# Access Compliance Report

## Public Rights-of-Way

Intersection ID: 13568	Main Street: ARLINGTON_AV	Cross Street: SOUTH_BV	Location: S
ADA ID: 1CDC40520B6D	Ramp Type: PerpDiag	Initial Pass/Fail: Fail	Overall Compliance: No
		Severity Score: 25

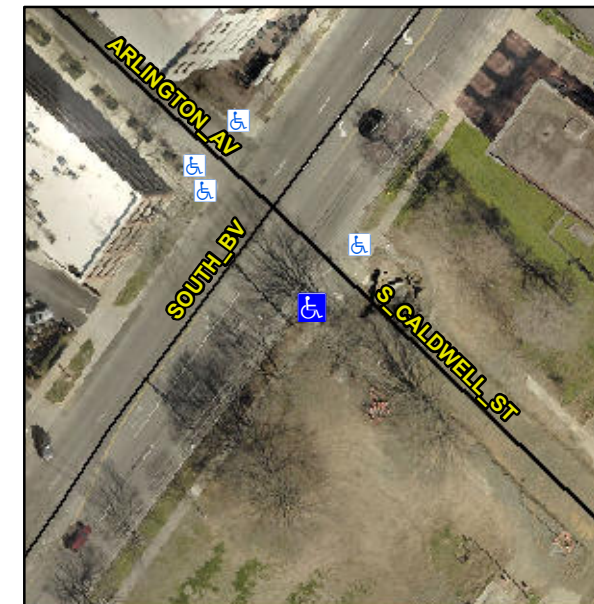
**Not Found, R304.5.3**

Compliance	Description	Data	Compliance	Description	Data
N/A	Ramp Length (in)	48.0	Yes	Ramp Slope (%)	5.6
Yes	Ramp Width (in)	48.0	No	Ramp XSlope (%)	8.1
N/A	Flare Type LT	N/A	N/A	Flare Type RT	N/A
N/A	Flare Slope LT (%)	N/A	N/A	Flare Slope RT (%)	N/A
N/A	Flare Traversable LT?	N/A	N/A	Flare Traversable RT?	N/A
N/A	Landing Length (in)	N/A	N/A	DWS Provided?	N/A
N/A	Landing Width (in)	N/A	N/A	DWS Contrast?	N/A
N/A	Landing Slope (%)	N/A	N/A	DWS Length (in)	N/A
N/A	Landing X Slope (%)	N/A	N/A	DWS Full Width?	N/A
N/A	Landing Curb? (Y/N)	N/A	N/A	DWS Offset (in)	N/A
N/A	Shared Landing?	N/A			
N/A	Gutter Ponding?	N/A	N/A	Gutter Slope (%)	N/A
N/A	Gutter Lip Ht (in)	N/A	N/A	Gutter X Slope (%)	N/A
N/A	Painted X Walk1?	Yes	N/A	Painted X Walk2?	No
	X Walk 1 Direction	To NE		X Walk 2 Direction	To NW
N/A	X Walk 1 Width (in)	118.0	N/A	X Walk 2 Width (in)	N/A
	X Walk 1 Slope (%)	0.1		X Walk 2 Slope (%)	5.8
	X Walk 1 X Slope (%)	7.0		X Walk 2 X Slope (%)	0.7

**Remove & Replace Curb Ramp With Two New Directional Ramps or Equivalent.**
